DATE OF MEETING | April 23, 2018 |

**SUBJECT** | **DEVELOPMENT PERMIT APPLICATION NO. DP1078 – 3200 ISLAND HIGHWAY NORTH** |

To present for Council's consideration a development permit application for a single-storey drive-thru restaurant. |

# ATTACHMENT D BUILDING ELEVATIONS

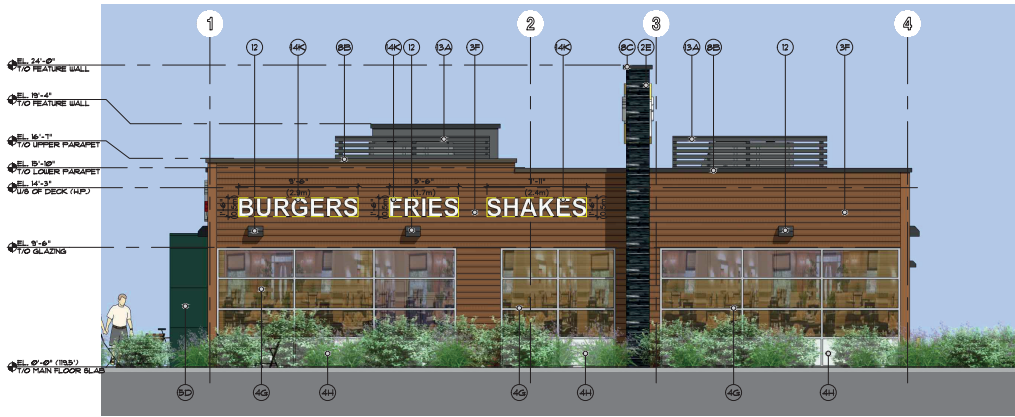
The building includes two fascia signs on an architectural feature which project above the roof line:

1. North Elevation: signage is included along a stone column element above the drive-thru window. The wall is considered an architectural feature and the sign does not project more than 1.2m above the roof line, no variance is required for this sign.
2. East/West Elevation: The east and west elevations include a blade wall column feature with signage projecting 2.1m above the roofline of the building. The column is considered an architectural feature; however, a variance is required to permit the signage more than 1.2m above the roofline.

The maximum allowable projection above the roofline for fascia signs located on an architectural feature is 1.2m. The applicant proposes two signs on the east and west elevations of a column feature which project 2.1m above the roofline, a proposed variance of 0.9m. The signage on the column is not obtrusive; it provides exposure to the Island Highway and adds visual interest to the building. Staff support the proposed signage variance.

1. *Section 3 (6)* prohibits a sign or portion thereof that extends or projects above the roofline of a building. *Section 5 (4)(D)* permits fascia signage when located on an architectural feature to project 1.2m above the roofline. The proposed fascia signage within the architectural feature is 2.1m above the roofline, a variance of .9m.
